Bulletin No.	TS79 034
Date	June 20, 1979
Classification	TM79-003
Section	Transmission
Models	810, S130, 620

## FS5W71B TRANSMISSION

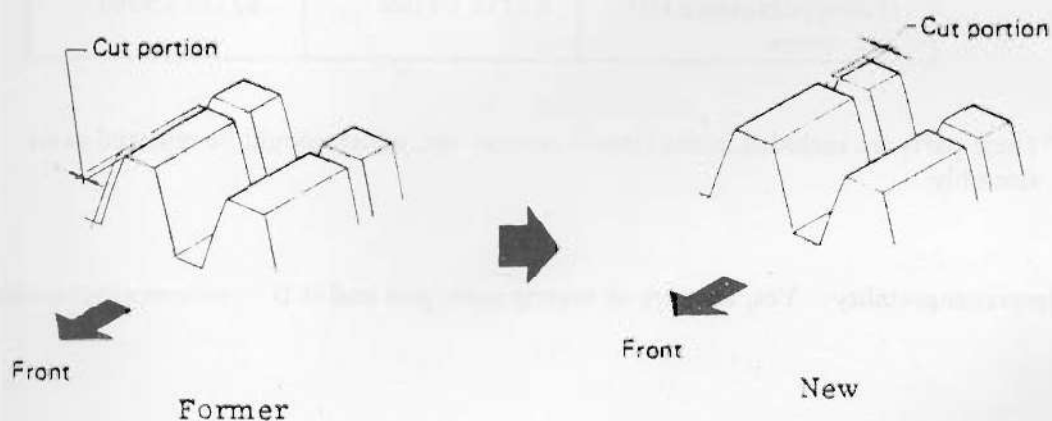
**Production Change.** To improve operation and standardize parts, the reverse main gear and overdrive — reverse hub have been changed.

### 1. Reverse main gear.

### 2. OD — Reverse synchronizer hub

The hub spline has been redesigned as shown below.
